## ADDENDUM NO. 1

To: All Planholders  
From: Frank A. Ferris, PE  
Subject: United Irrigation District  
Pump Station E458  
Date: August 16, 2024

UNITED IRRIGATION DISTRICT  
PUMP STATION E458  
PAVING, GRADING, & FENCING PLAN

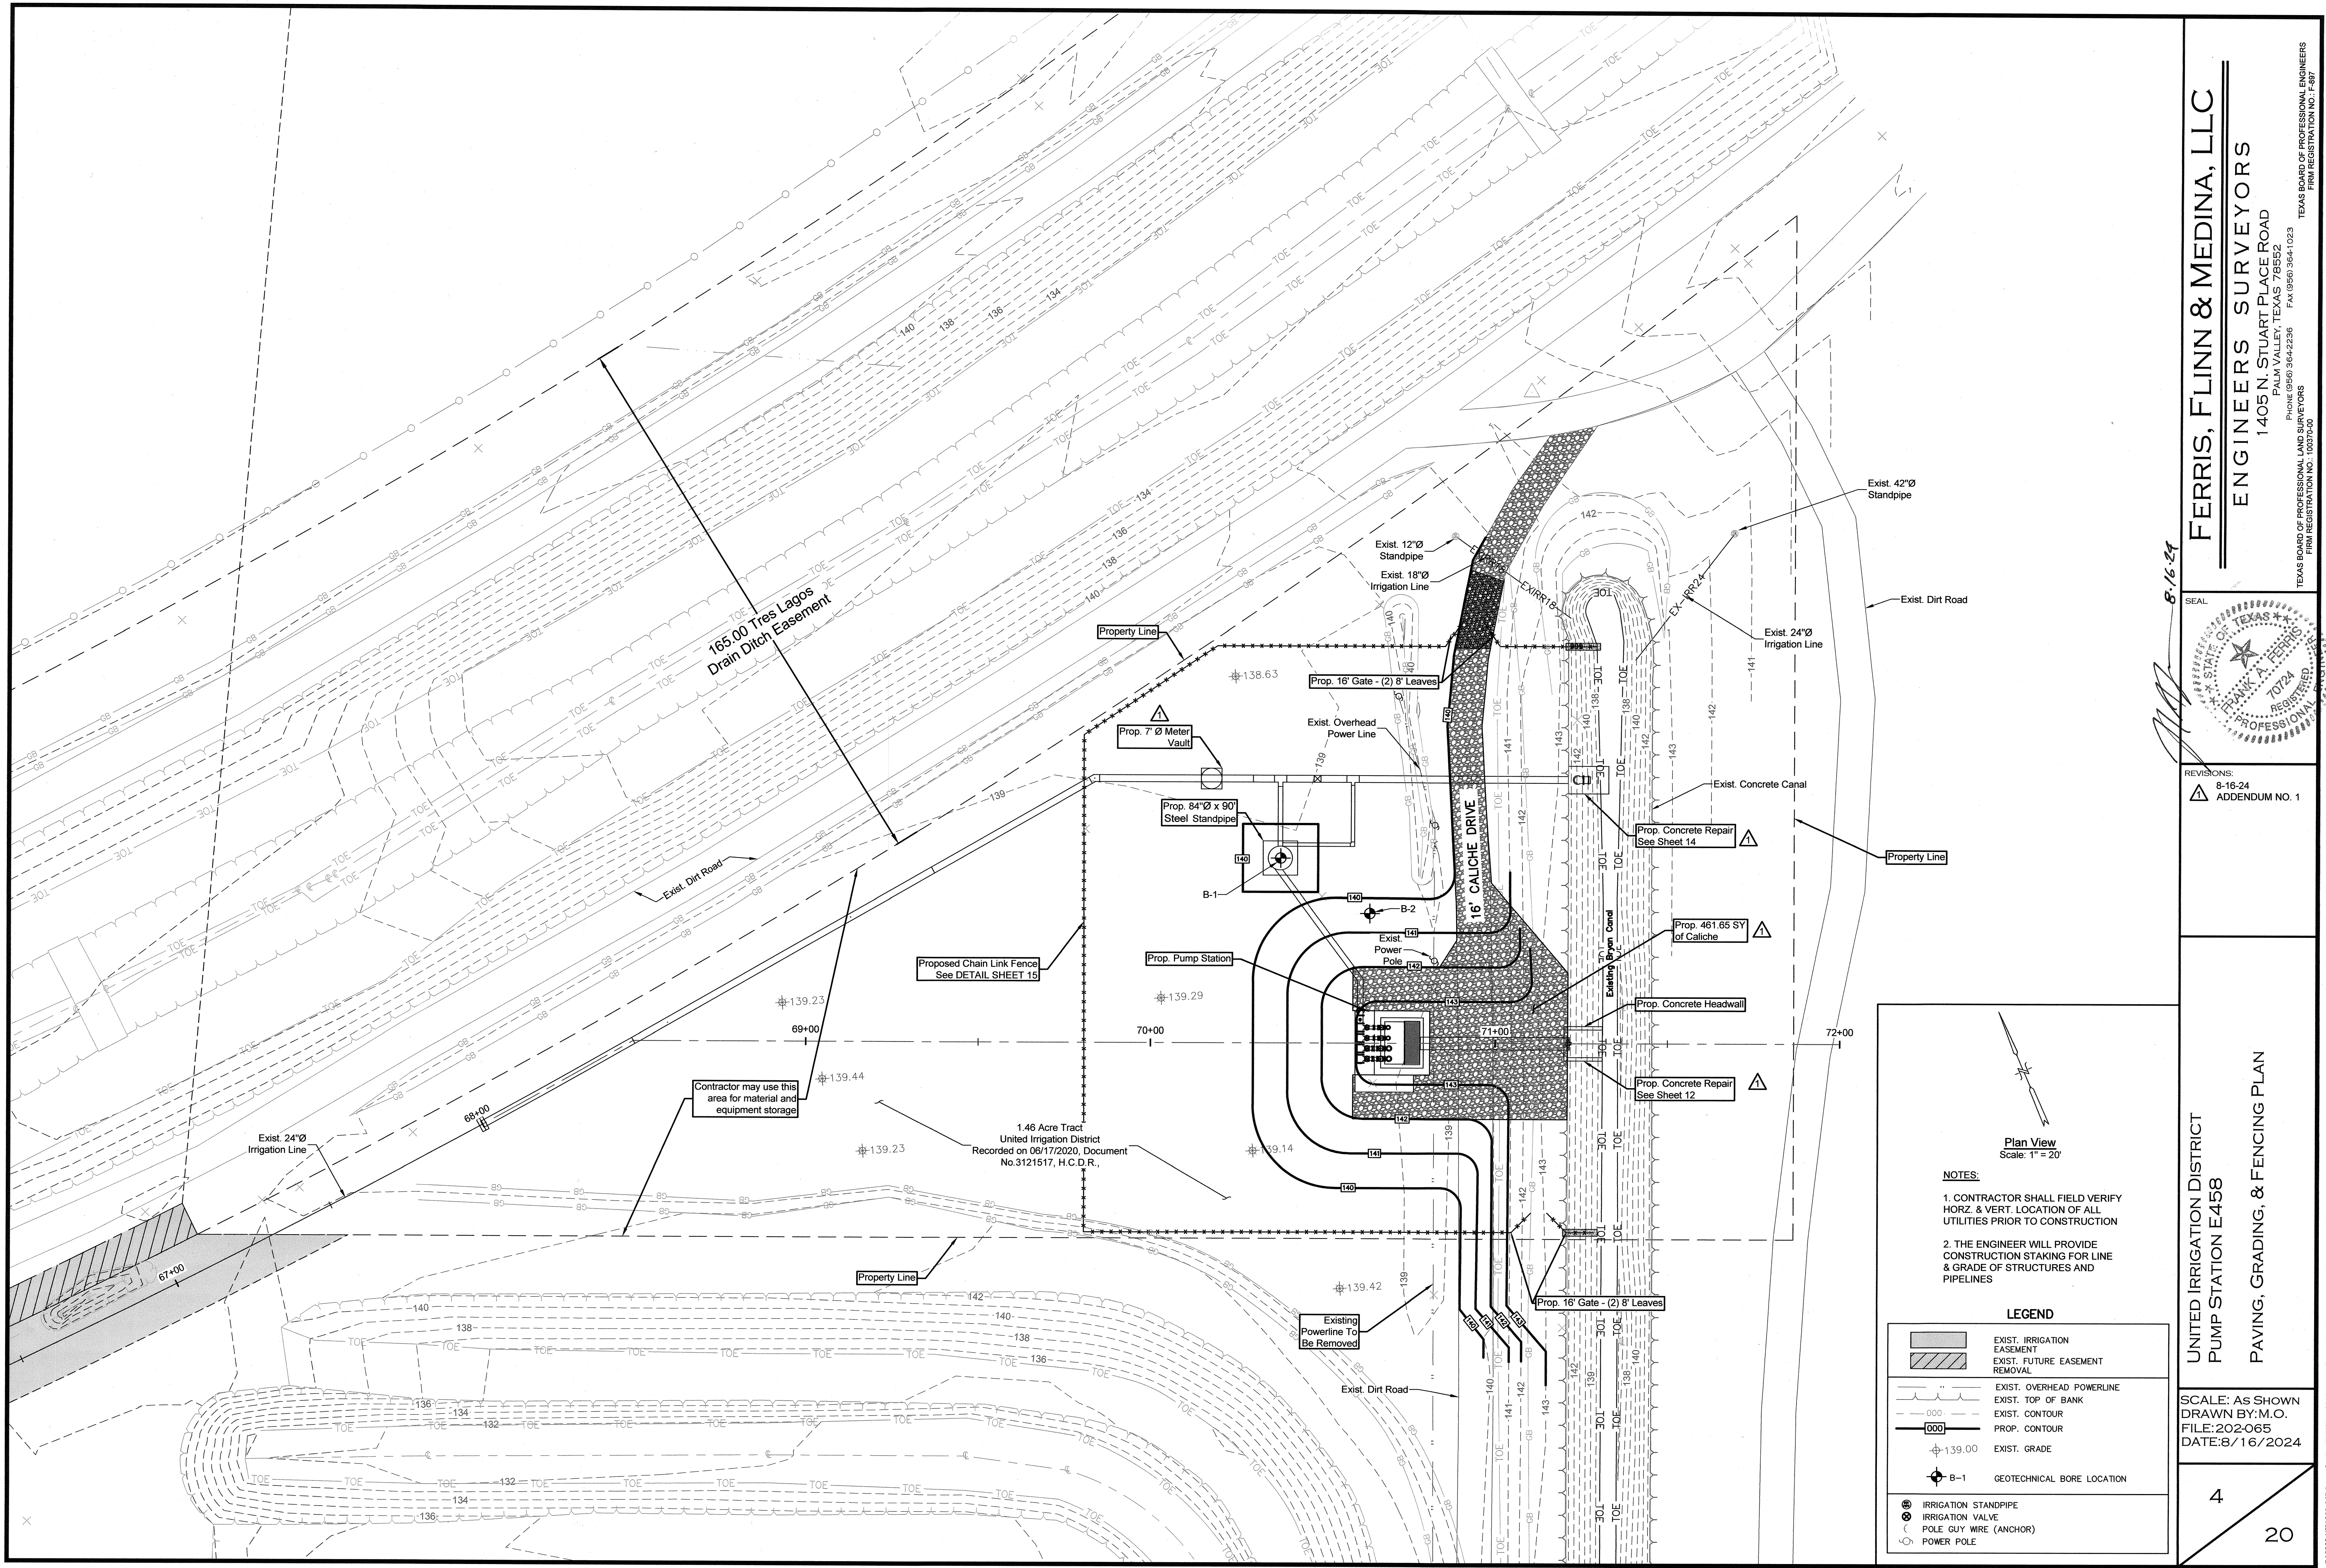
Replace Plan Sheet 4 with the attached Plan Sheet 4, 8-16-24 Addendum No. 1.
